HYDROGEOLOGICAL ASSESSMENT OF THE MOUNTAIN VALLEY PIPELINE APPLICATION TO THE VIRGINIA MARINE RESOURCES COMMISSION

Prepared for **Preserve Bent Mountain**

Prepared by Pamela C. Dodds, Ph.D., Licensed Professional Geologist

October 25, 2017

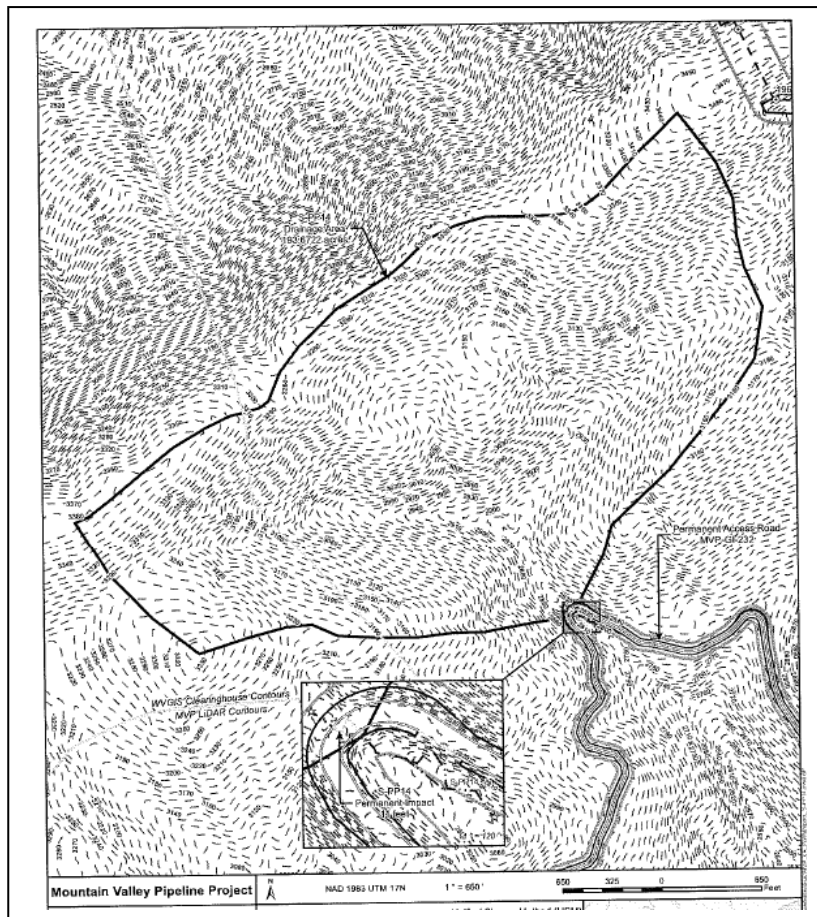
In the MVP application to VMRC, Table 4 “Proposed Stream Mitigation” lists MVP identified streams S-PP14 and S-PP15 as being crossed by access road MVP-GI-232. These two streams are unnamed tributaries to Kimballton Branch. Field sheets and subwatershed delineations are provided for S-PP14 (**Figure 1.1-1**) and S-PP15 (**Figure 1.1-2**) in MVP Standard JPA-NWP12 Pre-Construction Notification, Virginia, Attachment H-2: Wetlands and Waterbodies Impact Analysis and Compensatory Mitigation Plan.

The delineations for S-PP14 and S-PP15 are depicted as 193.6722 acres and 190.3249 acres, respectively. Both S-PP14 and S-PP15 are first order high gradient streams and are unnamed tributaries to Kimballton Branch. A watershed can refer to the overall system of streams that drain into a river, such as the Stony Creek watershed which is greater than 5 square miles (3,200 acres) in size, or can pertain to a smaller tributary. Stream order is a measure of the relative size of streams. The smallest tributary is a first order stream. First order high gradient tributaries form in headwater areas at the highest elevations in watersheds. Because of the impacts of construction on the functions of headwater areas in the watersheds of upland first order high gradient streams, it is critical to evaluate these areas not simply as a small acreage within the area encompassing the construction project, but rather as functionally contributing areas which are 1) the basis of water quality and aquatic habitat quality within the overall watershed, and 2) the base of the aquatic food chain for the overall watershed.

MVP has not adequately evaluated the increase in impervious areas resulting from the proposed construction and has not adequately evaluated the cumulative impacts of increased stormwater discharge to streams within watersheds that would be impacted by the proposed MVP construction.

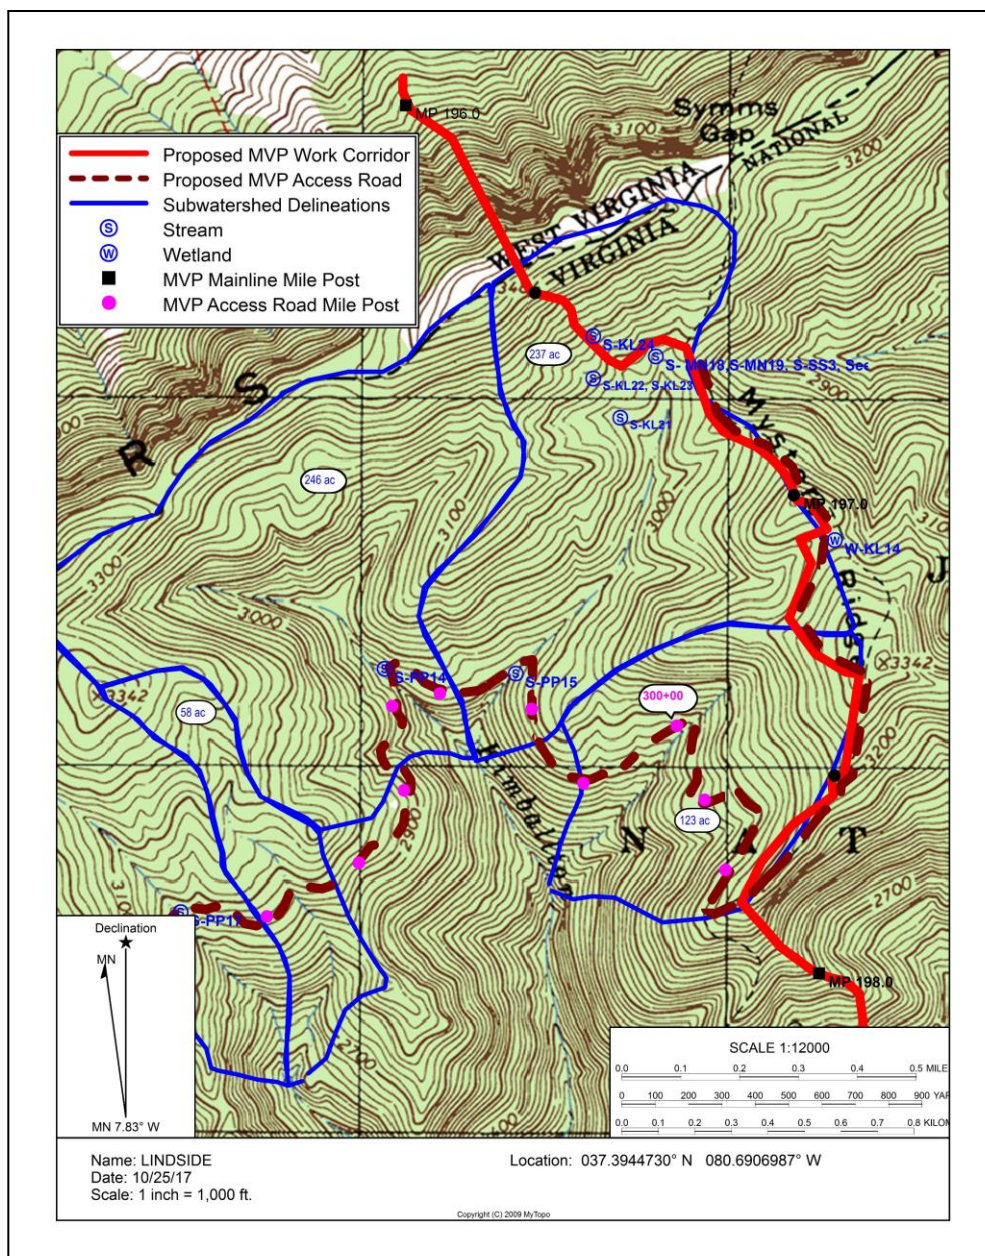
Table 1.1-1 provides the stream information provided by MVP in the FEIS and in the MVP Aquatic Resource Report for US National Forest Service (National Forest) Lands, Monroe County, West Virginia; Giles and Montgomery Counties, Virginia (June 2017). Not all of the information for stream crossings within the Kiballton Branch watershed has been included in the VMRC application.

| Specific Subwatershed Location | Acres in Subwatersheds Delineated | Description |
|--|-----------------------------------|---|
| Kimballton Branch Subwatershed Access Road MVP-GI-232 MP 250+00 to MP 272+00 | 246 acres | MVP identifies the uppermost first order stream segment of Kimballton Branch as S-PP14, described as a perennial stream. This stream is a high gradient first order stream with a headwater area near the apex of Peters Mountain. MVP states that 50 lineal feet of stream S-PP14 would be crossed by the proposed access road MVP-GI-232. |
| Kimballton Branch Subwatershed Access Road MVP-GI-232 MP 272+00 to MP 285+00 AND Mainline Work Corridor between MP 196.5 and MP 196.7 | 237 acres | MVP identifies this stream as an unnamed tributary to Kimballton Branch, with the lower portion identified as S-PP15, which would be crossed by the MVP Pocahontas access road at Station 278+00. Stream S-PP15 is a high gradient first order stream. MVP identifies the following additional streams that are in the headwater areas of stream S-PP15 and that would be crossed by the proposed MVP work corridor: S-KL24, an intermittent stream that would be crossed at MP196.5; S-KL21, an intermittent stream that would be crossed at MP 196.6; S-KL22, a perennial stream that would be crossed at MP 196.6, S-KL23, a perennial stream that would be crossed at MP 196.6; S-SS3, an intermittent stream that would be crossed at MP 196.7; S-MN18, an intermittent stream that would be crossed at MP 196.7; and S-MN19, an intermittent stream that would be crossed at MP 196.7. MVP states that 15 lineal feet of stream S-PP15, 31 feet of stream S-MN18, and 38 feet of stream S-MN19 would be crossed by the proposed access road MVP-GI-232. Wetland, W-KL14, in the uppermost headwater areas of this watershed, would be crossed by the MVP mainline work corridor at MP 197.1, with permanent impacts. Wetland W-KL14 is a PEM wetland, with HGM classification as Slope, kept moist by groundwater recharge. |
| Kimballton Branch Subwatershed Mainline Work Corridor between MP 197.3 and MP 197.8 | 123 acres | Although clearly shown on the USGS topographic map as an intermittent stream, MVP did not identify this first order stream tributary to Kimballton Branch which is shown by MVP as being crossed by proposed Access Road MVP-GI-232 MP 300. A deeply incised ravine is also located in this subwatershed delineation, indicative of an ephemeral or intermittent stream. The headwater areas for these streams extend to the proposed MVP work corridor between MP 197.3 and MP 197.8, and are also crossed by the proposed MVP-GI-232 between MP 285+00 and intersection with the proposed MVP work corridor. |

Figure 1.2-1 – Topographic map depicting the subwatershed delineations of unnamed tributaries to Craig Creek. (Map developed by P.C. Dodds, Ph.D., using Terrain Navigator Pro software.)

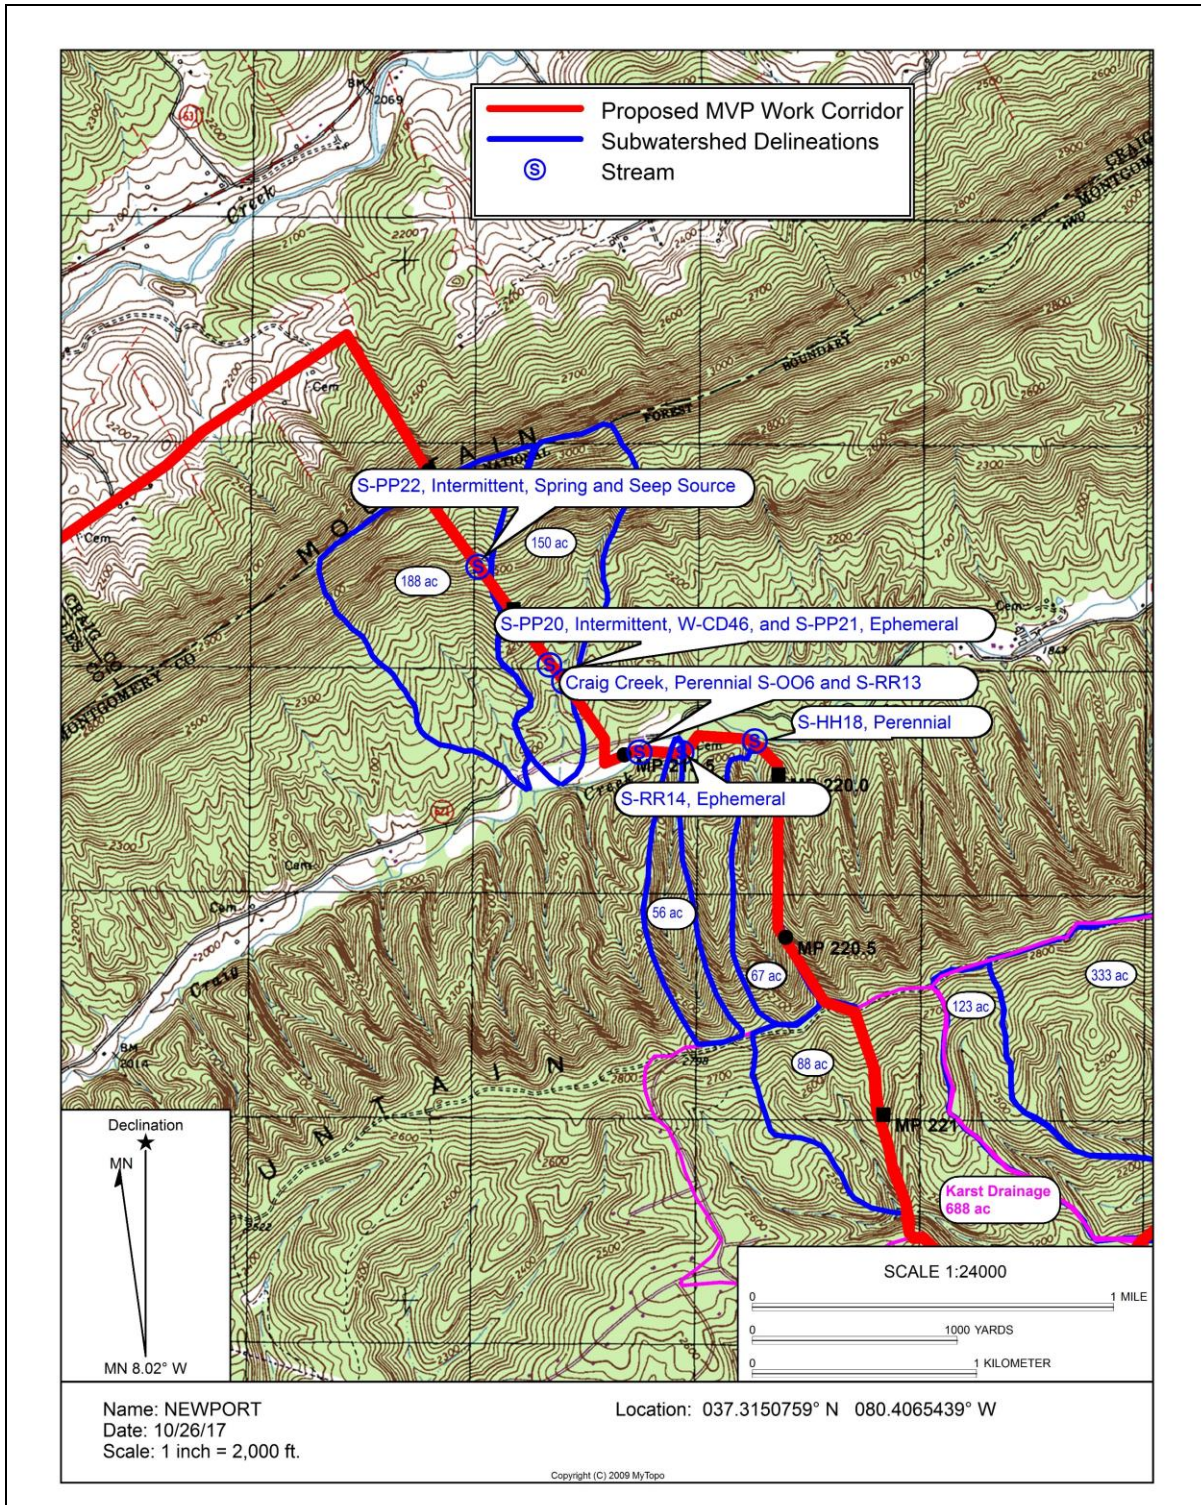
MVP has listed the proposed Craig Creek crossing as not having any permanent impact and has therefore not listed the Craig Creek crossing in its Joint Permit Application #17-1609 submitted to the Virginia Marine Resources Commission. In the MVP FEIS Appendix F, the following classifications are listed for Craig Creek: 1) propagation and maintenance of fish and other aquatic life, 2) coldwater trout stream, 3) threatened and endangered species. It is also listed as being crossed by the open-cut dry ditch method and having permanent acreage impact within the “Permanent Easement/Temporary Workspace” project component. As shown on **Figure 1.2-1**, the following UNTs to Craig Creek are also proposed by MVP for crossing: S-PP20 (intermittent; propagation and maintenance of fish and other aquatic life), S-PP21 (ephemeral), S-PP22 (intermittent; propagation and maintenance of fish and other aquatic life), S-RR14 (ephemeral), and S-HH18 (perennial; propagation and maintenance of fish and other aquatic life). Deforestation of areas where the unnamed tributaries are proposed by MVP for crossing will result in adverse impacts to the aquatic habitats in these headwater areas by causing increased light, increased temperatures, and increased surface runoff from precipitation. Deforestation for pipeline construction will increase stormwater discharge from the delineated subwatersheds to Craig Creek. Dewatering of seeps and springs, with drainage pipes to the ground surface will increase stormwater discharge from the delineated subwatersheds to Craig Creek. Trench dewatering with permanent trench breakers and drains directing the groundwater to the ground surface will increase stormwater discharge from the delineated subwatersheds to Craig Creek. The result will be a permanent increase stormwater discharge to Craig Creek which will cause stream bank erosion, thereby releasing sediments to Craig Creek and increasing stream embeddedness, continually. This is in addition to the turbidity and sedimentation resulting from the proposed MVP trenching and construction activities. The increased turbidity and sedimentation (embeddedness) will adversely impact the aquatic habitats that 1) currently support macroinvertebrates for trout and other fish to use as a food source and 2) currently serve as protective areas for juvenile trout and other juvenile fish.

| SPECIFIC SUBWATERSHED LOCATION | ACRES IN SUBWATERSHEDS DELINEATED | DESCRIPTION |
|--|--|---|
| Craig Creek Subwatershed MVP MP 218.55 to MP 218.9 | 188 acres | MVP identifies one stream as an unnamed tributary (UNT) to Craig Creek as S-PP22, described as an intermittent stream to be crossed by the proposed MVP work corridor at MP 218.8. This stream is within the headwater area of another high gradient first order stream tributary to Craig Creek; however, the second stream is not identified by MVP. The headwater areas are near the apex of Sinking Creek Mountain. The proposed crossing would be 83 lineal feet for S-PP22. MVP field notes for S-PP22 state: "Stream sources from spring or seep then returns underground at the end point." |
| Craig Creek Subwatershed MVP MP 218.9 to MP 219.35 | 150 acres | MVP identifies 2 UNTs to Craig Creek as S-PP21, described as ephemeral, and S-PP20, described as intermittent. Wetland W-CD46 is shown associated with S-PP20 on the MVP Erosion and Sediment Control Plan Sheet 13.28ES (MVP Spread 9), but is not listed in the MVP FEIS or in the Joint Permit Application #17-1609. The streams would be crossed by the proposed MVP work corridor at MP 219.1 and MP 219.2, respectively. Both streams are high gradient first order streams with headwater areas near the apex of Sinking Creek Mountain. The proposed crossing would be 97 lineal feet for S-PP21 and 89 lineal feet for S-PP20. |
| Craig Creek Subwatershed MVP MP 219.65 to MP 219.8 | 56 acres | MVP identifies one UNT to Craig Creek as S-RR14, described as an ephemeral stream, to be crossed by the proposed MVP work corridor at MP 219.7. This stream is a high gradient first order stream with headwater areas near the apex of Brush Mountain and also along the steep ridges at the delineation perimeters. The proposed crossing would be 78 lineal feet. |
| Craig Creek Subwatershed MVP MP 219.89 to MP 219.91 | 67 acres | MVP identifies Craig Creek as S-OO6 (proposed work corridor crossing) and as S-RR13 (proposed access road crossing) and one UNT to Craig Creek as S-HH18. Craig Creek and S-HH18 are both described as perennial. The MVP proposed crossing of S-OO6 is 76 lineal feet and of S-RR13 is 41 lineal feet. Stream S-HH18 would be crossed by the proposed MVP work corridor at MP 219.9. S-HH18 is a high gradient first order stream to Craig Creek, with headwater areas near the apex of Brush Mountain and also along the steep ridges at the delineation perimeters. The proposed crossing would be 78 lineal feet for S-HH18. The proposed MVP work corridor is located along the entire length of the eastern watershed perimeter ridge of this watershed, extending from approximately MP 219.91 to approximately MP 220.75. |

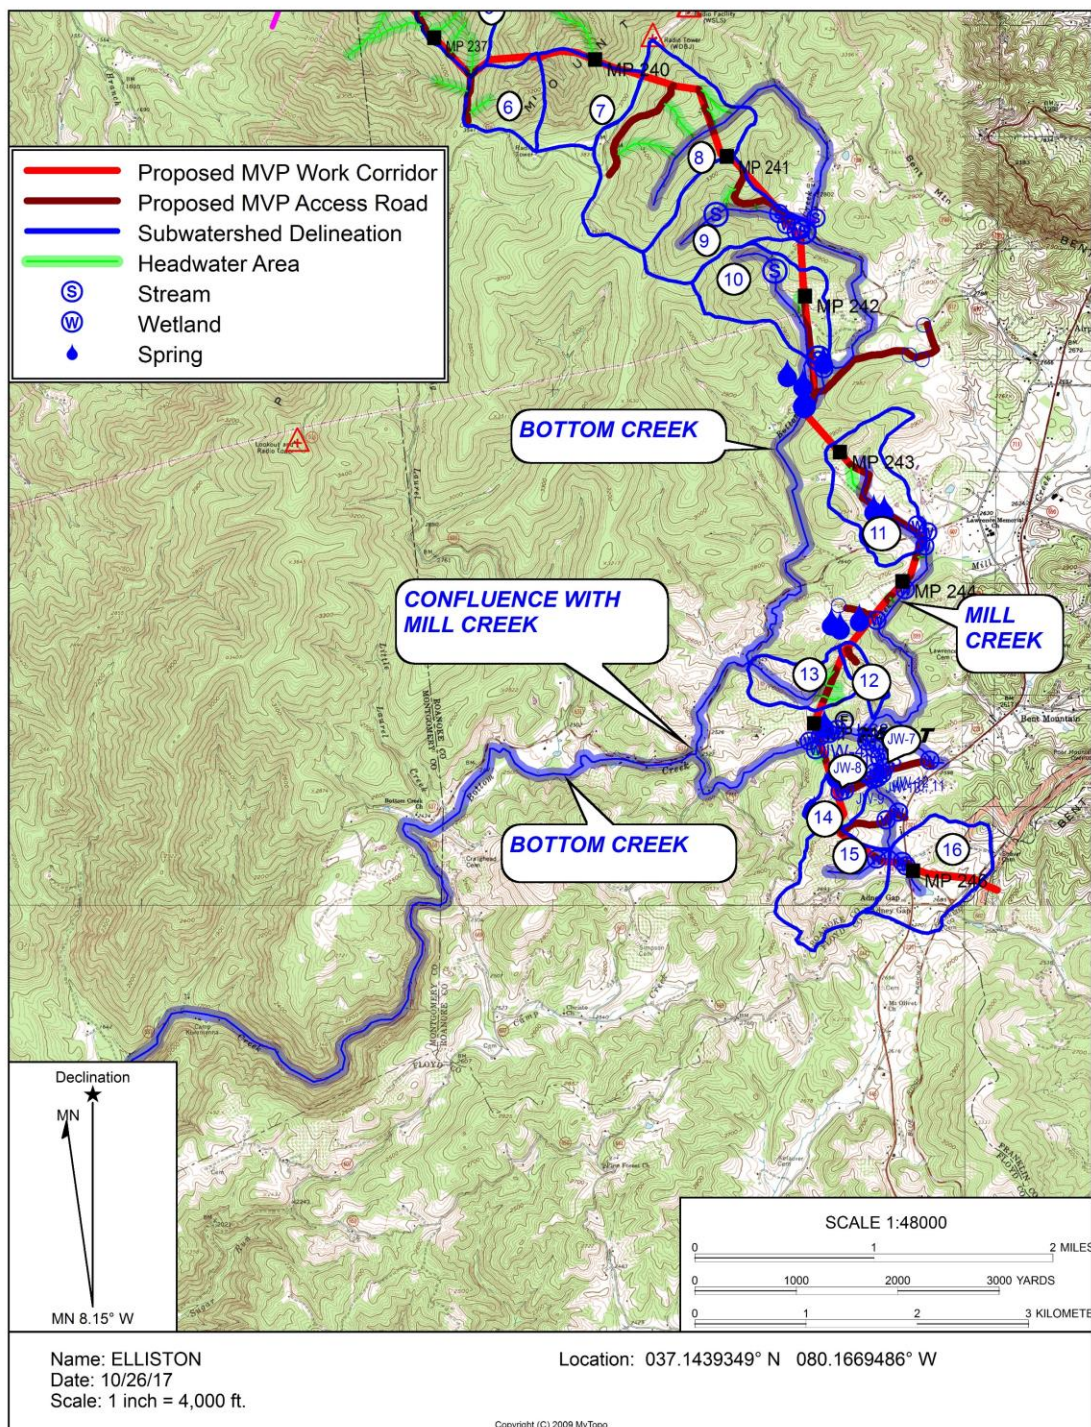
The UNTs in the headwater areas of the Bottom Creek watershed and the Mill Creek watershed provide the required environmental factors of filtered light, lower temperatures, moist soil conditions, and soil functions to maintain aquatic habitats for aquatic species at the base of the ecological continuum for Bottom Creek and for Mill Creek. The Virginia Water Quality Standards 9 VAC 24-280 (January 2011) classify Bottom Creek as natural trout waters extending from its confluence with the South Fork Roanoke River upstream, including all named and unnamed tributaries, that is, including Mill Creek and all its tributaries.

| LOCATION | ACRES | DESCRIPTION | SPRINGS | WETLANDS |
|---|-------|--|--|---|
| Subwatershed 8 MP 240.2 to MP 241.0 | 362 | MVP estimates 77 lineal feet of impact where mainline crosses the perennial high gradient first order UNT, designated as S-Y14, to Bottom Creek. MVP estimates 85 lineal feet of impact where mainline crosses intermittent UNT, designated as S-Y13, highlighted as a headwater area. MVP mainline also crosses 1 additional headwater area. The MVP access road connecting with the mainline at MP 240.3 crosses 2 headwater areas to S-Y14. | | |
| Subwatershed 9 MP 241.0 to MP 241.7 | 200 | MVP mainline is located within the stream valley of the UNT to Bottom Creek from MP 241.4 to 241.7. MVP estimates 140.0 lineal feet of impact to intermittent UNT designated TTVA-S-021, 43.9 lineal feet of impact to intermittent section of Bottom Creek, designated TTVA-S-022, 45.1 lineal feet of impact to perennial section of Bottom Creek designated TTVA-S-025, 258.6 lineal feet of impact to ephemeral UNT to Bottom Creek designated TTVA-S-023, and does not provide an estimated impact to intermittent UNT to Bottom Creek designated TTVA-S-024. Access road located adjacent to TTVA-S-021 crosses 2 headwater areas. | Numerous springs observed in areas adjacent to stream designation s and also within UNT TT-S-021 | TTVA-W-005 PEM, Depressional , located near MP 241.6 and TTVA-W-004 PEM, Slope, located near MP 241.5. Both wetlands impacted by mainline |
| Subwatershed 10 MP 241.8 to MP 242.4 | 194 | MVP estimates 21.0 lineal feet of mainline impact to intermittent UNT designated TTVA-S-26 and 194.4 lineal feet of mainline impact to ephemeral UNT designated TTVA-S-027, 630 lineal feet of mainline impact to perennial UNT designated TTVA-S-028, 13.5 lineal feet of mainline impact to intermittent UNT designated TTVA-S-029, and 101.1 lineal feet of mainline impact to Bottom Creek, designated TTVA-S-030. Mainline crosses 1 undesignated headwater area. | Several springs observed | MVP designated wetland TT-W-006 PSS, Riverine. Also, several wetlands observed |

MVP has not provided the VMRC with an accurate number of stream crossings within the Bottom Creek/Mill Creek watershed that would be permanently adversely impacted. MVP reported permanently impacted streams (**Table 1.3-3**) in its Draft Environmental Impact Statement (DEIS), but failed to include it in its Joint Permit Application #17-1609 to the VMRC.

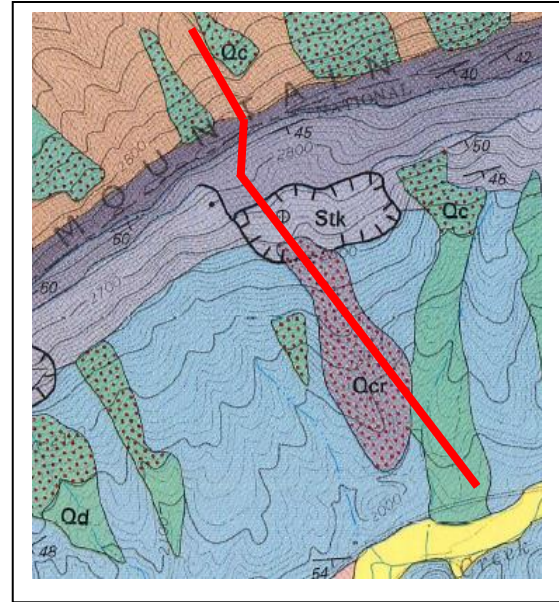
Schultz (1993) provides information concerning the large rock block landslides in the Sinking Creek Mountain area. Faulted bedrock dips to the southeast in this area. Interbedded shale strata are interpreted to be the sliding surfaces. **Figure 2.4-1** is an excerpt of the “Geologic Map of Large Rock Block Slides at Sinking Creek Mountain, Appalachian Valley and Ridge Province, Southwestern Virginia...” (Schultz, 1993) that provides details of the bedrock units underlying the Sinking Creek Mountain/Craig Creek area where the proposed MVP construction would cross the Jefferson National Forest.

Southworth and Schultz (1986) report that the Sinking Creek Mountain Complex is the largest known slide complex in eastern North America. The area of the slide mass is estimated to be 20 square miles at a thickness of 50 feet to 300 feet. The east-west length of the slide is approximately 20 miles up to 60 miles and the north-south width of the slide is 0.4 mile to 1 mile. The trigger for the slide is thought to be paleo-seismic.

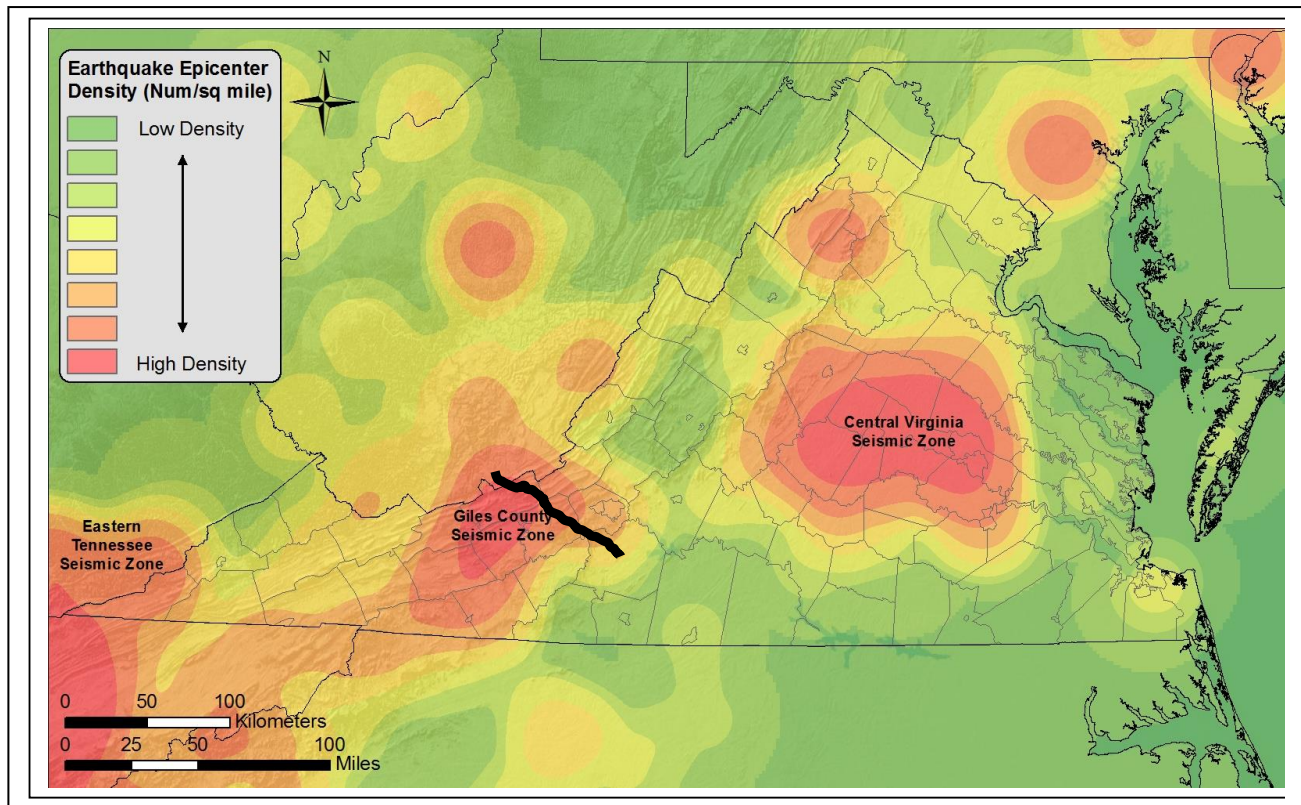
The Virginia Department of Mines, Minerals, and Energy developed an Earthquake Epicenter Density map (**Figure 2.5-1**) which depicts the area proposed for the MVP construction through Giles County, Montgomery County, Roanoke County, and Franklin County as positioned within the Giles County Seismic Zone.
